**GOODWIN UNIVERSITY EDUCATIONAL SERVICES, INC.**
**Special Meeting of the School Building Committee**
**September 22, 2026 at 12:00 pm**

Goodwin University
Magnet Technical High School
State Project #542-0007 MAG/N

**Subject: Progress Report**

**PCO #:** 073R1 - Added Glass Rail Clips RFI 202 nwith Powder Coating

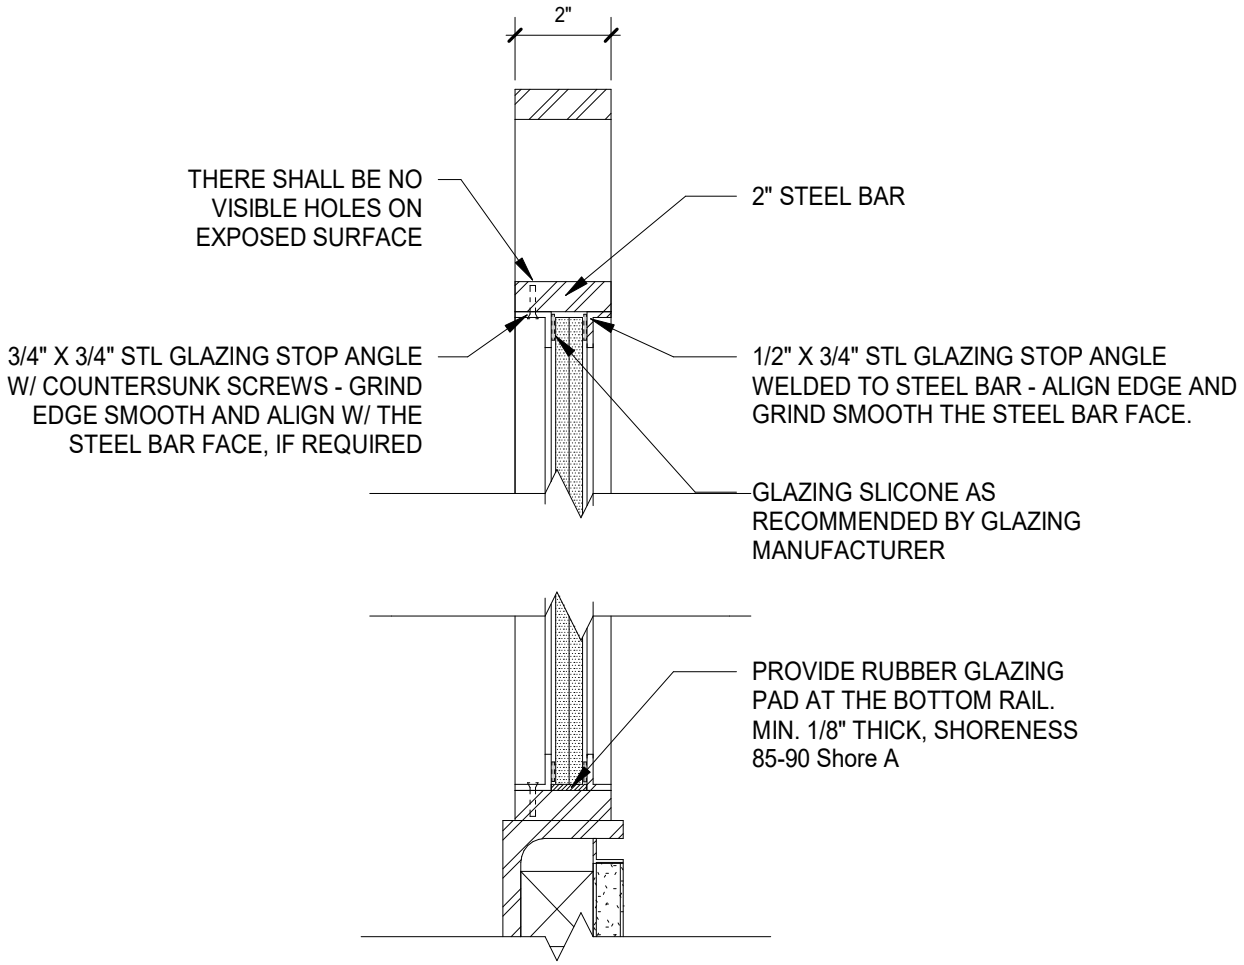
I. PCO#73R1 –RFI #202 Added Glass Railing Clips **$8,475**– Furnish and install additional glass railing clips. Work consists of providing 110 railing clips with additional powder coating for each clip used at the locations of the glass railings as required for customization due to field conditions as directed in RFI & sketch response.
Responsibility: Field Condition — **Eligible** / Ineligible

CE #115 - Added Glass Rail Clips
Addition of Glass Rail clips per RFI 202/ SKA 30
